***Prefinal Inspection Report for  
the Operable Unit 3-13 Tank  
Farm Interim Action, Phase II***

ICP/EXT-04-00602  
Revision 0  
Project Nos. 23614 and 20978

# **Prefinal Inspection Report for the Operable Unit 3-13 Tank Farm Interim Action, Phase II**

Figure C-1. Design drawing 624402 showing location of additional asphalt curbing (red line).

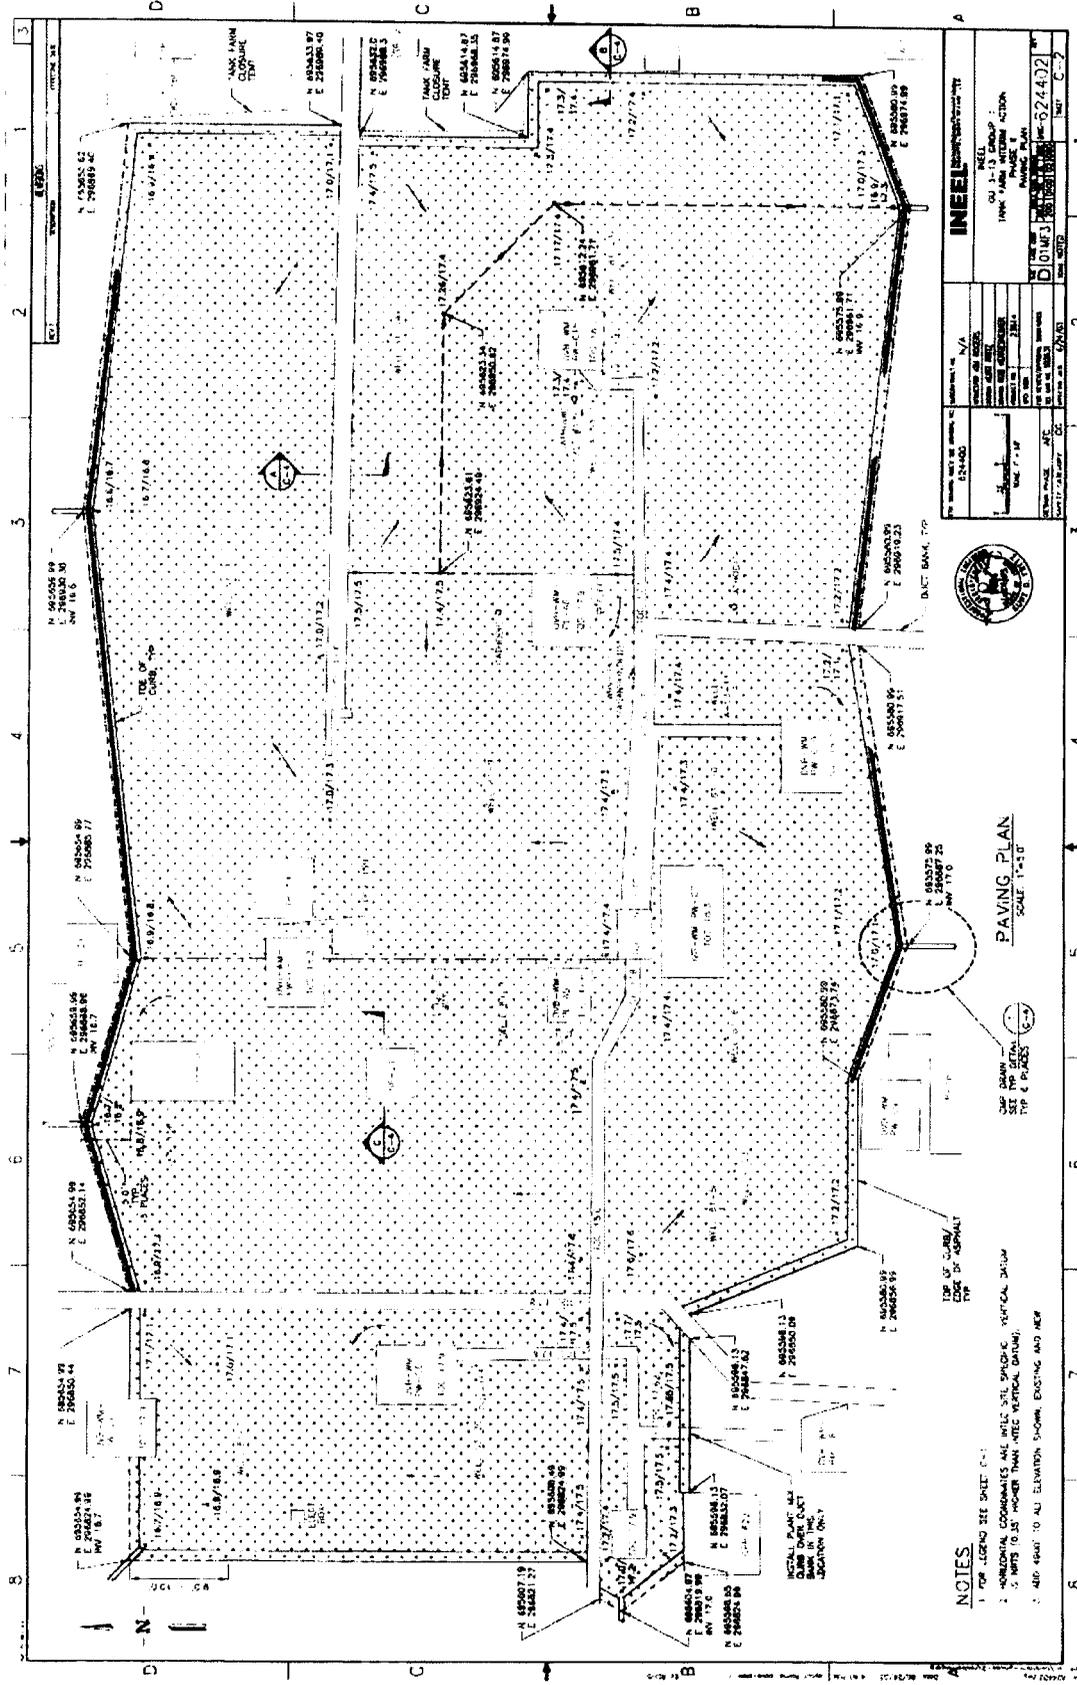
Agency Comment #6 *“Curbing at various locations, at drain pipe inlets in particular, is not adequate to prevent run-off from the asphalt. This comment also applies to the CPP-28, -79 areas. The current raised edge/curb of the asphalt, in several locations, does not take into account the effect of snow and ice accumulation and spring snow melt/rain events. DEQ and EPA consider this issue to be critical to the performance and intended function of the asphalt cover.”*

Action Taken Asphalt was increased/heightened at Zones D-2 through D-7 (DWG 624402) and A-1 through A-6 (DWG 624402), and at Zones D-4 through D-7 (DWG 624403). Refer to modified drawings, Figures C-1 and C-2, Appendix C.

Figure D-1. Application of blacktop asphalt filler and sealant between corrugated metal pipe and underlying asphalt.

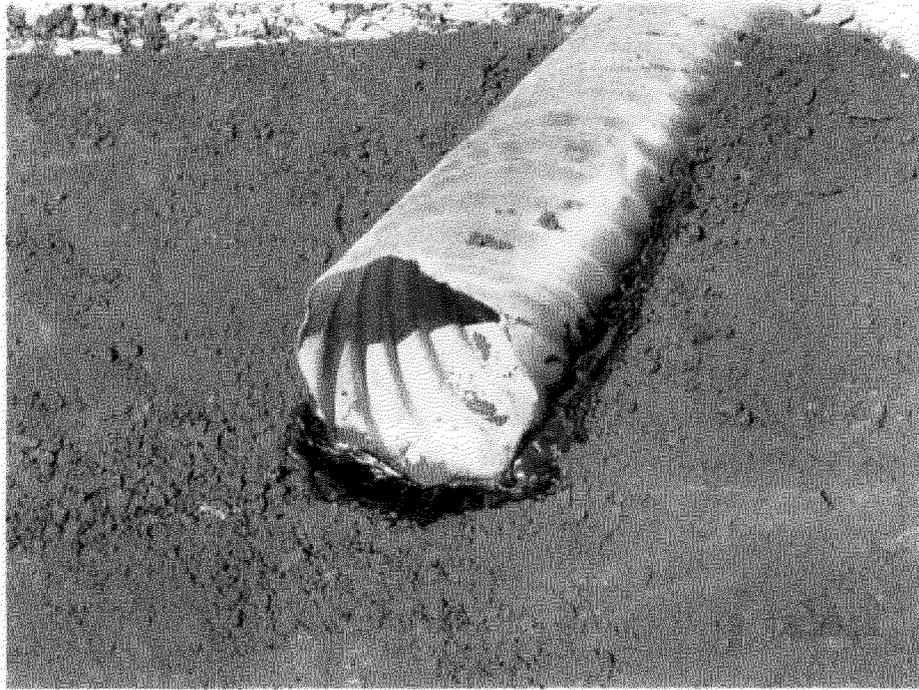
Agency Comment #1	<i>“Pipe boots need to be installed, at all drain lines, where the lines interface with the asphalt to prevent leakage at the joint.”</i>
Action Taken	As recommended by the project’s design engineer and with Agency concurrence during the Agency conference call (dated August 26, 2004), an adhesive sealant (DAP® Blacktop Asphalt Filler and Sealant) was applied between each corrugated metal pipe (CMP) and the underlying asphalt (refer to Figures C-1 and C-2 in Appendix C for CMP locations) to create a water-tight seal (see photo, Figure D-1, Appendix D).
Completion Date	September 9, 2004.
Agency Comment #2	<i>“Some drain lines are not yet placed in the final position; thus, these lines do not have a continuous downgradient invert flow line.”</i>

Figure D-3. Ballast tubes placed at 30-ft intervals over high-density polyethylene piping

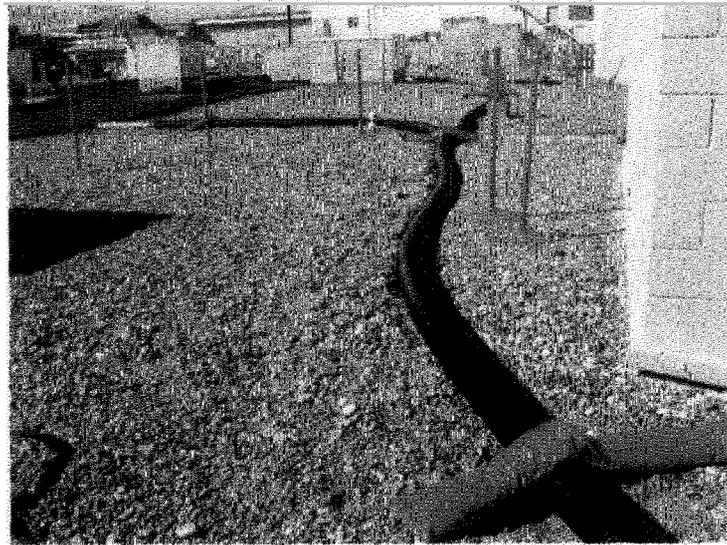
Agency Comment #3 *“Not all drain lines have ballast placed at 30 foot intervals.”*

Action Taken Additional ballast tubes were fabricated and placed along each HDPE drainpipe at 30-ft intervals and within 10 ft of each discharge point. HDPE drainpipe has been permanently marked at 30-ft intervals to assist with adequate ballast placement and as an aid to properly replace ballasts if temporary removal is required to accommodate ongoing construction activities (see photo, Figure D-3, Appendix D).
